➤ **Subject** Control Number 316429

Re: Docket No. 03037525, Control No. 316429

NEW LICENSE: 32-32666-01 DOCKET NO. 03037525 CONTROL NO. 316429

InstroTek, Inc. Organizational Chart

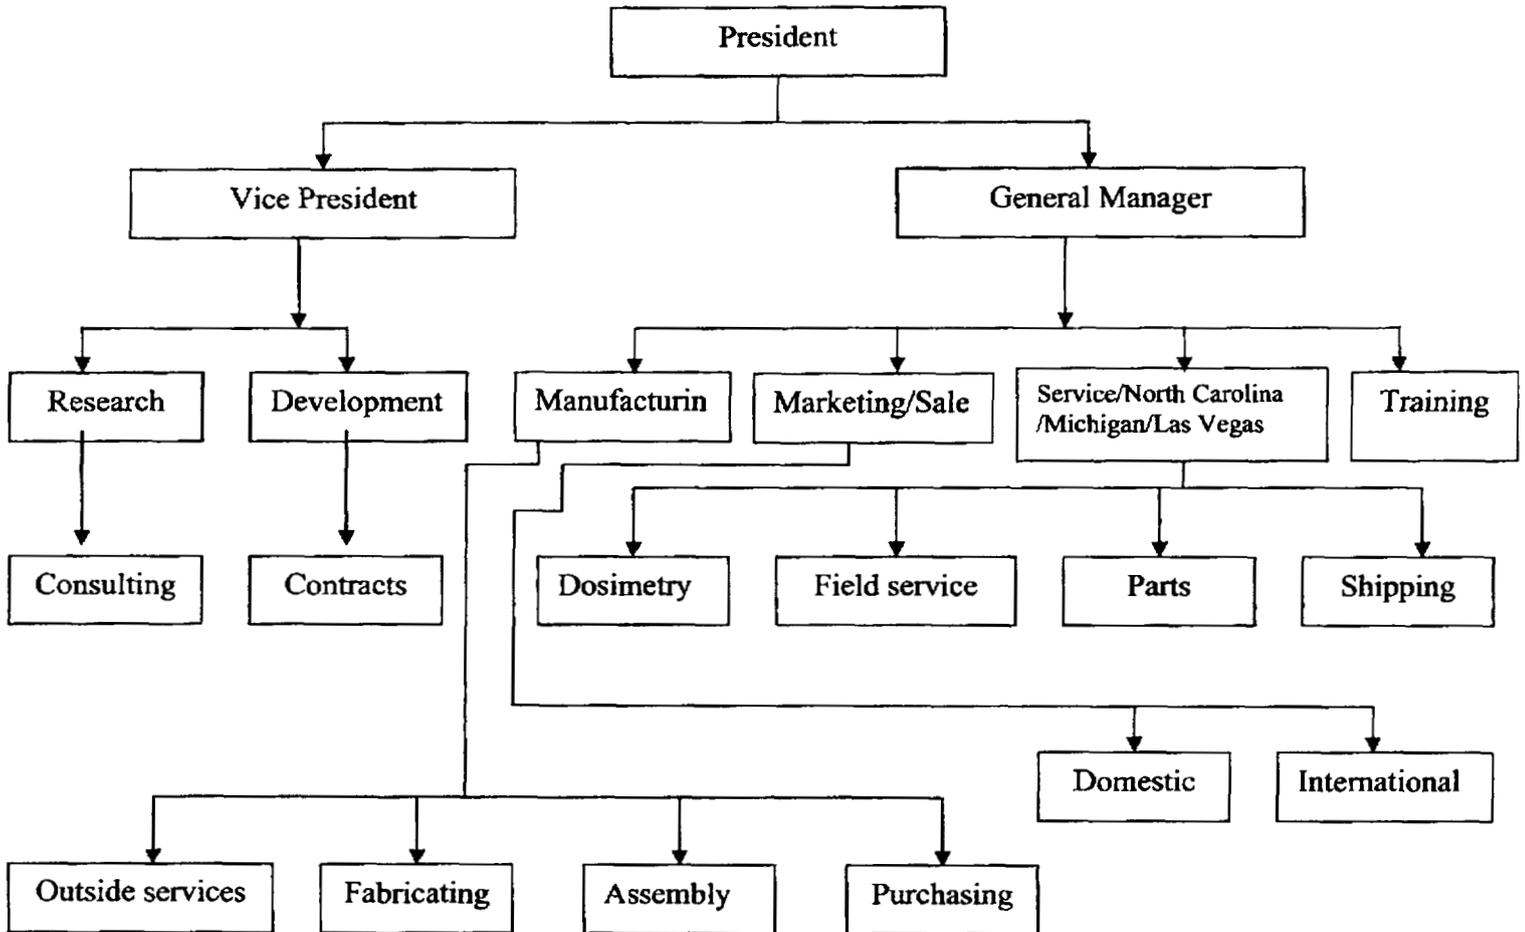
- A discussion of reasonable alternatives that have been considered.
4. Please indicate a maximum quantity of each radionuclide you intend to possess.
 5. Please provide an organizational chart that includes the proposed Grand Rapids facility.

- 5- Organizational chart attached
- 6- Letter attached from Emil Albouyeh the proposed RSO
- 7- Training documentation and requirements are attached. Please note most of the training for the new technicians will be done at a senior technicians work bench and work area. Other training is performed in a training class or work area relevant to the specific training that is being provided. The trainee has constant access to a trainer and senior technician at all times.
We provide on-going training to all our technicians, as new regulations are introduced and as new product/services are launched.
